**METROPOLITAN GOVERNMENT OF NASHVILLE AND DAVIDSON COUNTY**

**STAFF RECOMMENDATION**  
**1207 Dallas Avenue**  
**August 21, 2019**

**Application:** Violation/Show Cause; New Construction—Addition and Outbuilding  
**District:** Belmont-Hillsboro Neighborhood Conservation Zoning Overlay  
**Council District:** 18  
**Base Zoning:** R8  
**Map and Parcel Number:** 11801006200  
**Applicant:** Preston Quirk, Architect  
**Project Lead:** Sean Alexander, sean.alexander@nashville.gov

Left side of partially-constructed addition to 1207 Dallas Avenue, current condition.

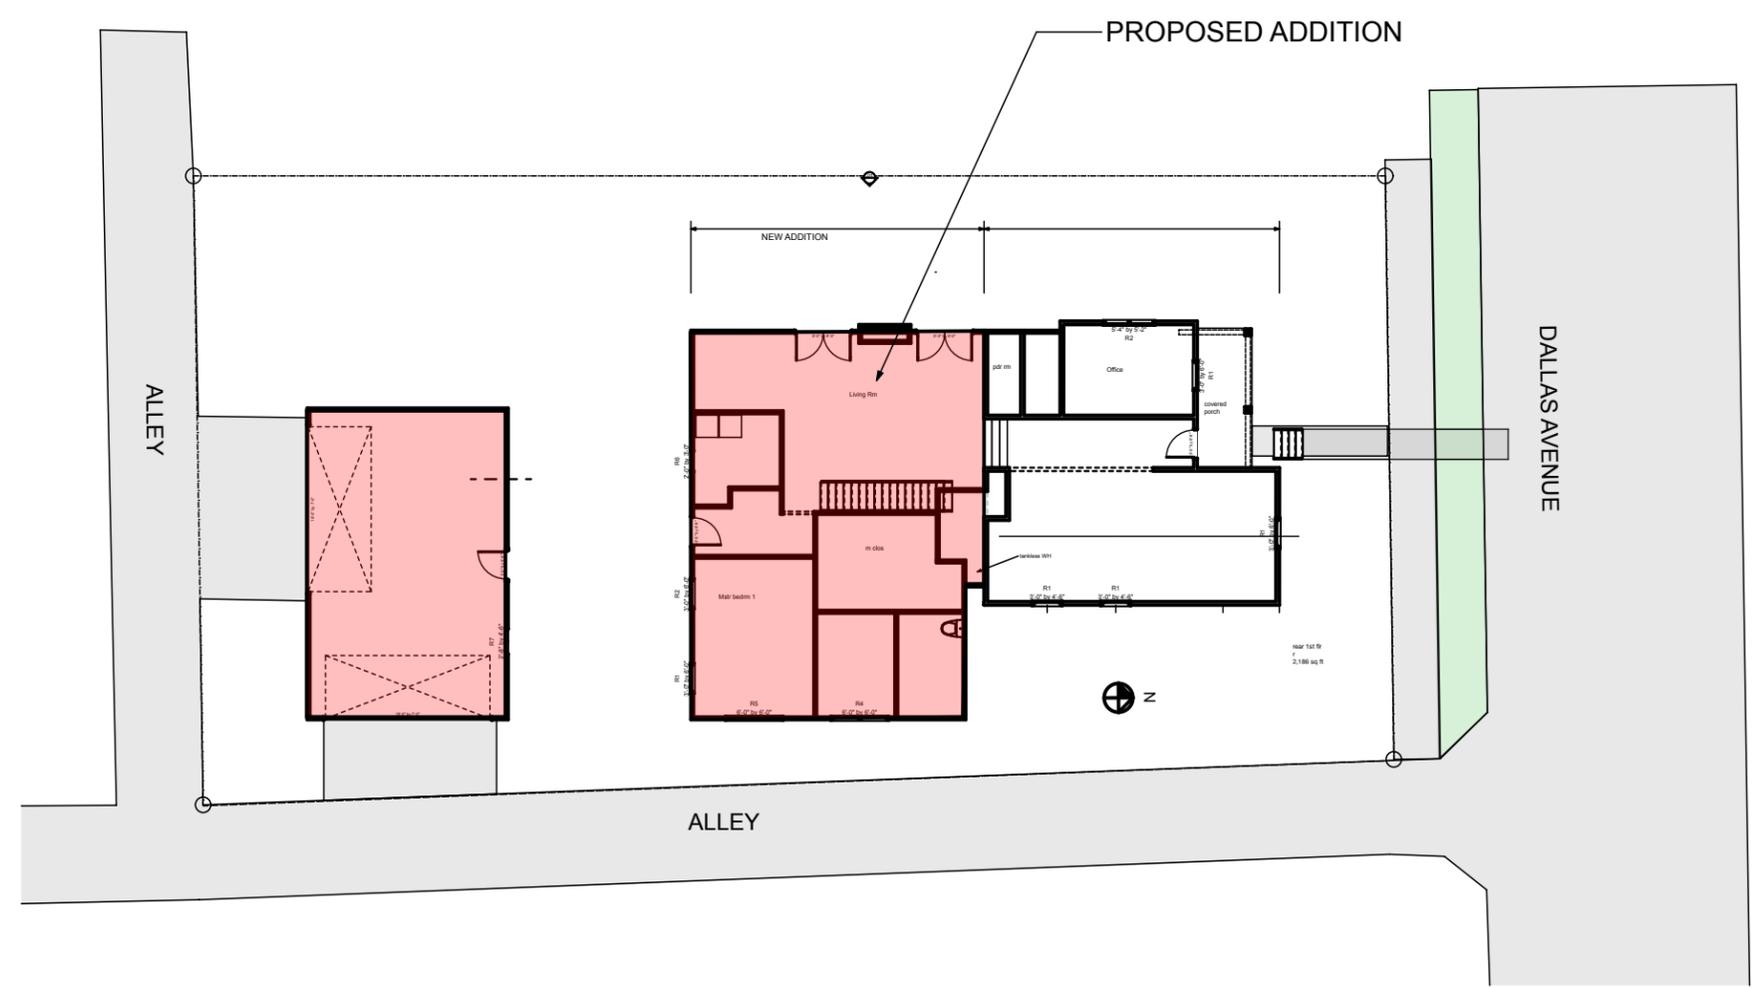
Figure 1: 1207 Dallas Avenue, left side. Although approved to be shorter than the historic house with a matching eave height, the addition was built with the eave and roof height significantly taller.

The addition was constructed with the eaves and roof taller than the corresponding components of the historic house. The walls of the historic house were not directly impacted by the addition, but rather than originating behind the original massing, the roof of the addition originated near the center of the structure, causing it to increase the height of a section of the roof and change a portion of the gabled roof to a hipped roof

ELEVATIONS 1

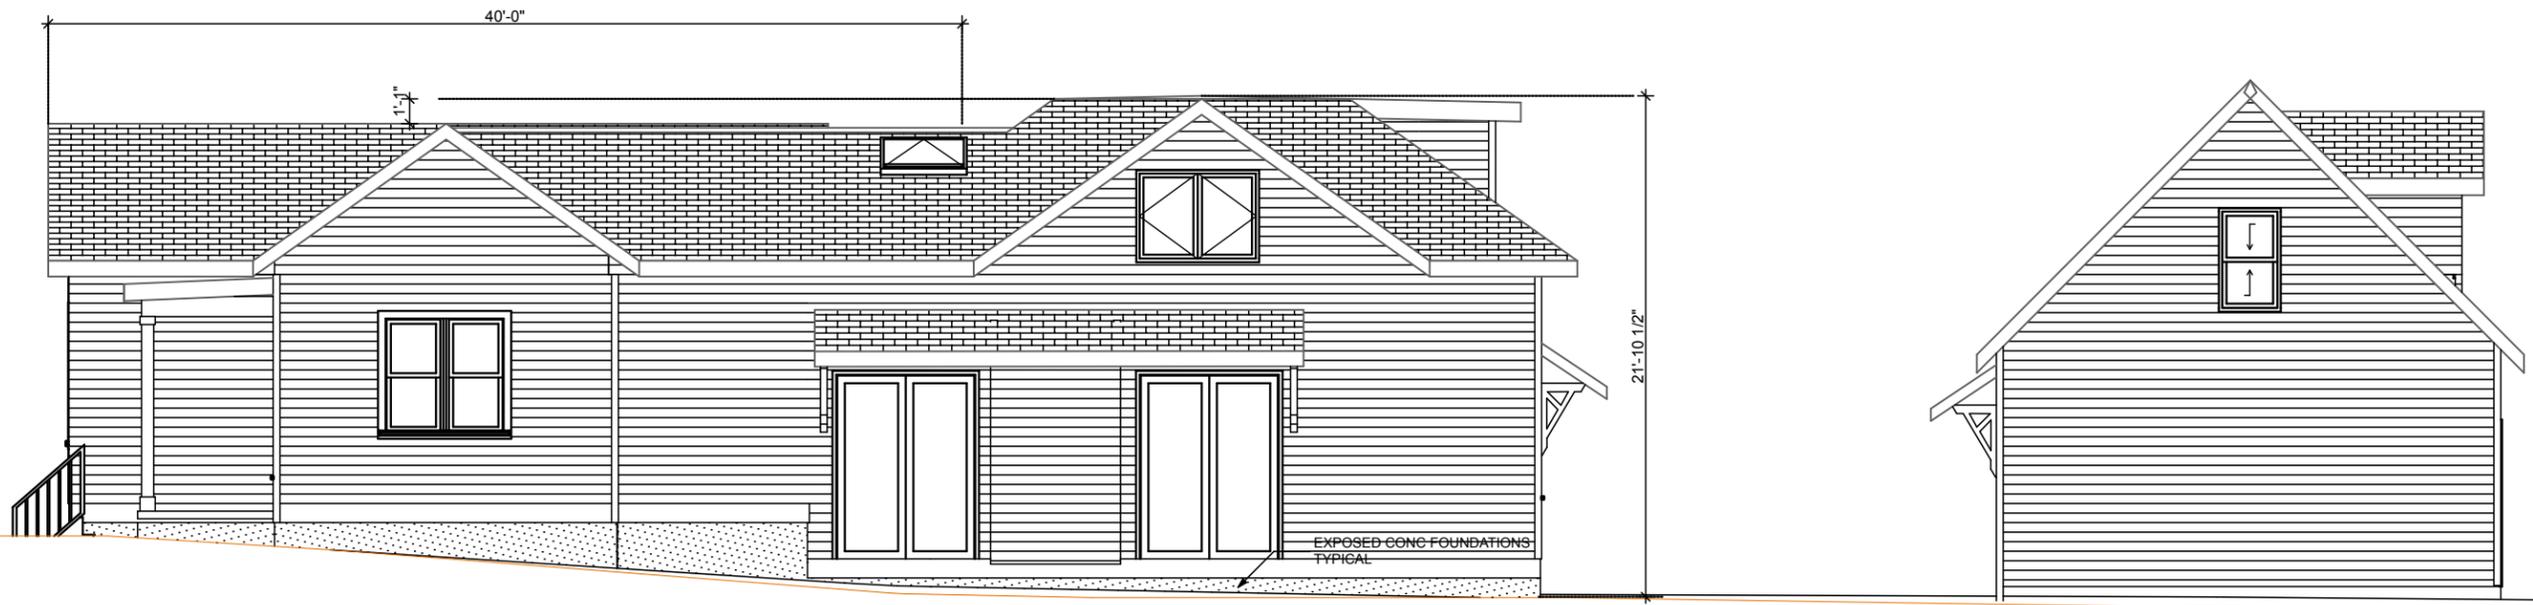
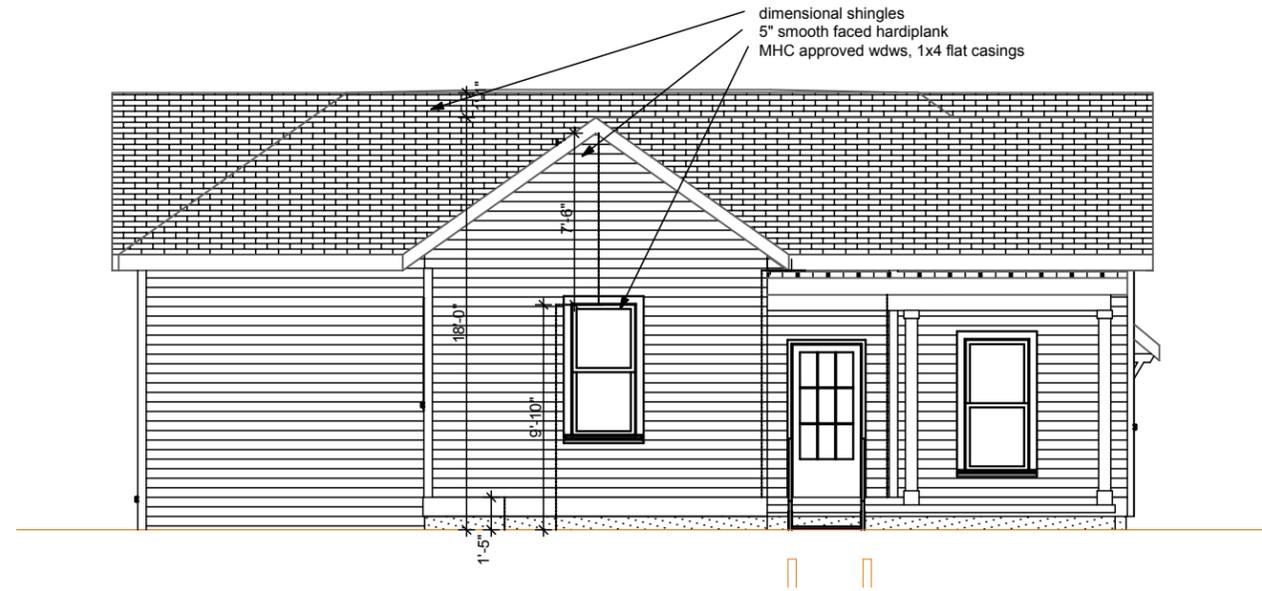
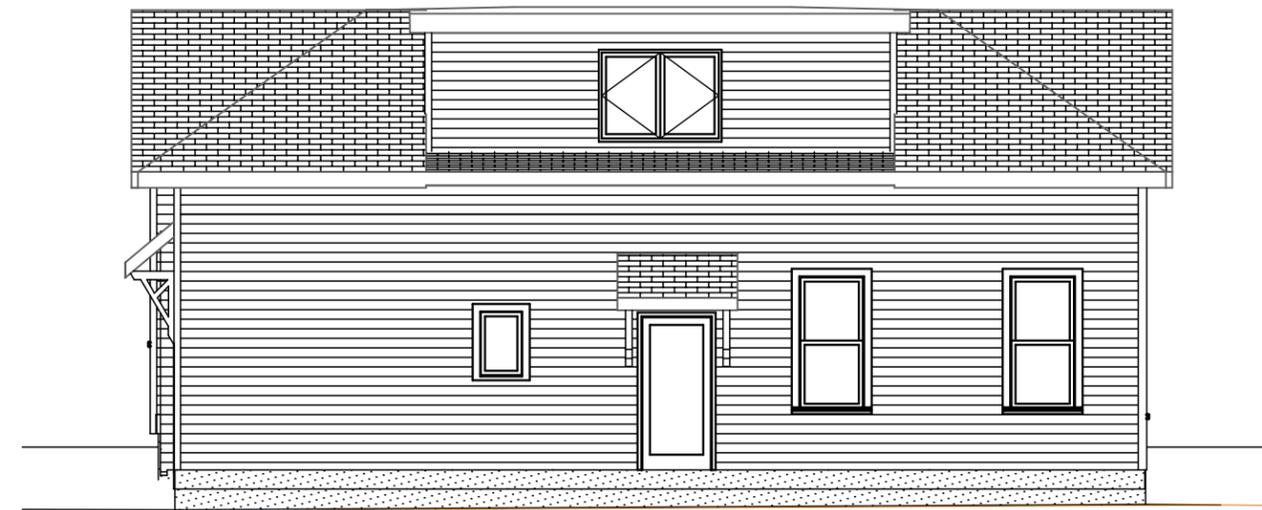
As constructed, the addition inappropriately alters the form and increases the height of the historic building. The current proposal would restore the original gabled-ell form of the historic house and connect the bulk of the addition with a narrower hyphen before stepping wider and taller. The roof of the hyphen, however, would tie flush into the original left side of the roof. Typically, the roofs of additions must also be differentiated from an original roof form to preserve the integrity of the historic building's form. Staff finds the location and removability of the proposed modification would not meet Sections II.B.2.a. and II.B.2.e of the design guidelines because the hyphen is not sufficiently differentiated at the roof.

The current proposal would remove the constructed upperstory and replace it with a new, shorter upperstory. The modified addition would have eaves matching the eave height of the historic house, with a roof that rises thirteen inches (13”) higher than the ridge height of the original roof.

Because the proposed addition would exceed the height and width of the historic house simultaneously, staff finds that the proposed modification to the addition does not meet sections II.B.1a and II.B.1.b of the design guidelines.

Roof form: The proposed modification to the addition would have a hipped roof component behind the primary mass of the historic house, with gable projections to the left and right and a side dormer to the rear.

Staff finds that the roof of the addition is not compatible with that of the historic house, and that the addition as constructed does not meet Section II.B.1.e of the design guidelines.

**Recommendation:** Staff recommends disapproval of the proposed modification to the addition at 1207 Dallas Avenue, finding it does not meet Sections II.B.2.a. and II.B.2.e (Location and Removability) and II.B.1.b. (Scale) of the design guidelines, because the addition's roof is not sufficiently differentiated from the original roof and because the addition is simultaneously taller and wider than the historic house.

GARAGE

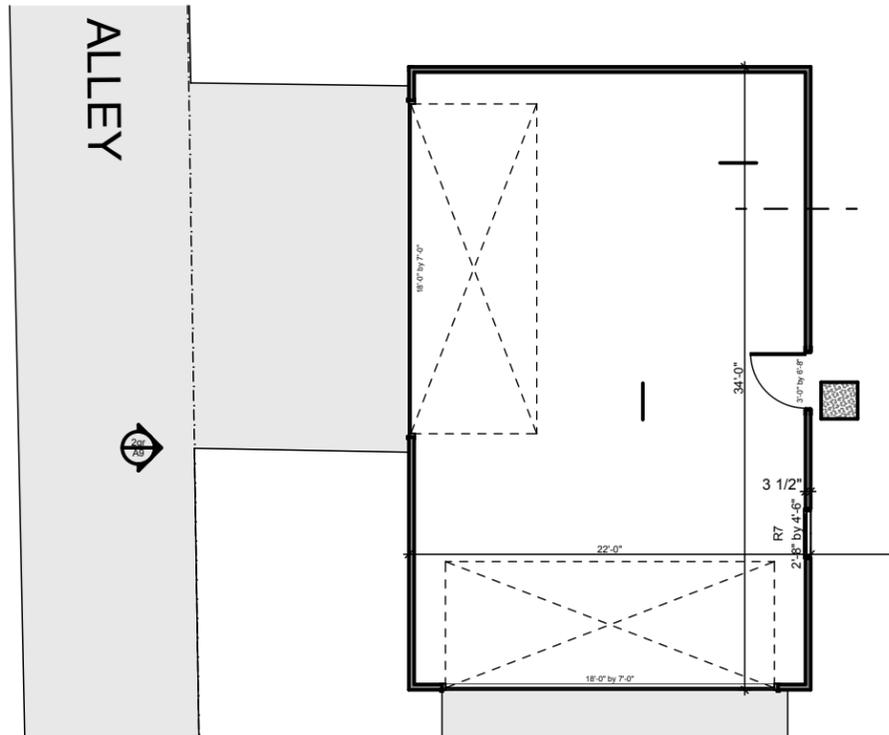
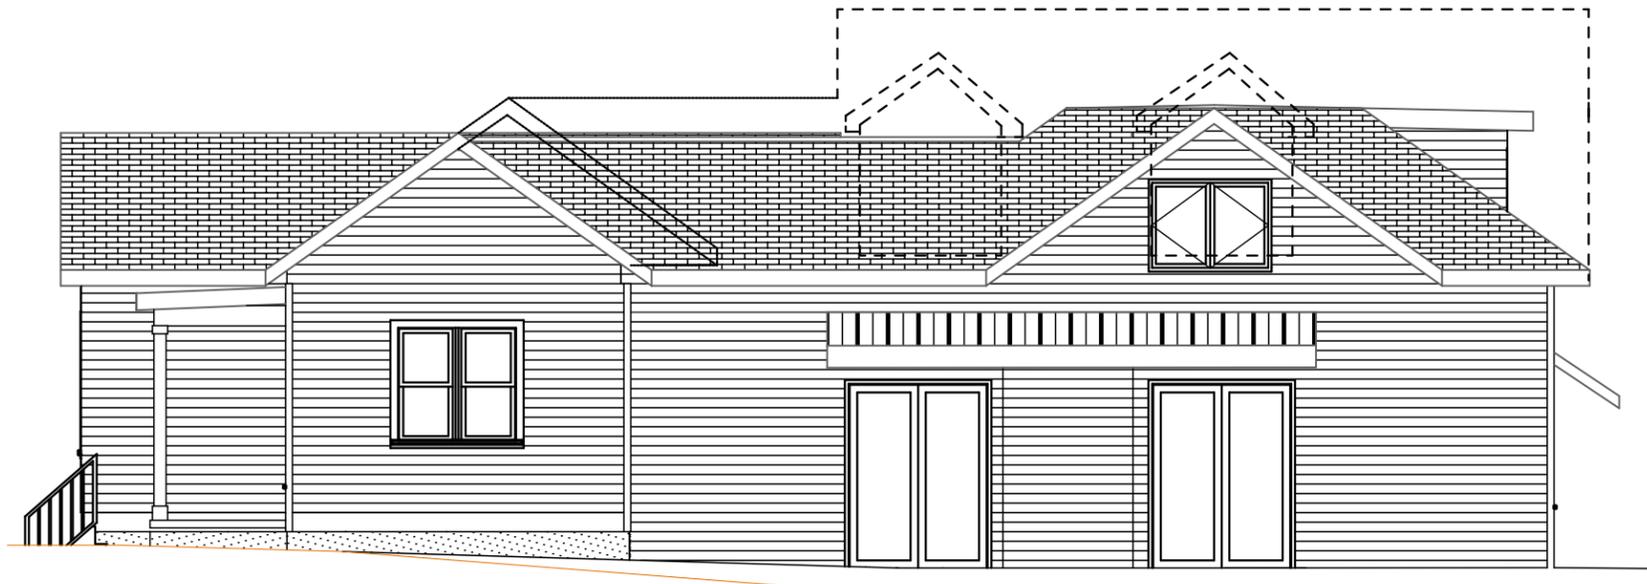
Outbuilding: As constructed, the outbuilding has a dormer on the north façade that does not step back from the first story wall as is typically required. The current proposal is to remove that dormer.

Staff finds that the proposed modification to the outbuilding would meet Section III.B.h. of the design guidelines

Staff recommends approval of the proposed modification to the outbuilding, finding that it does meet Section III.B.h. (Outbuildings) of the design guidelines because.
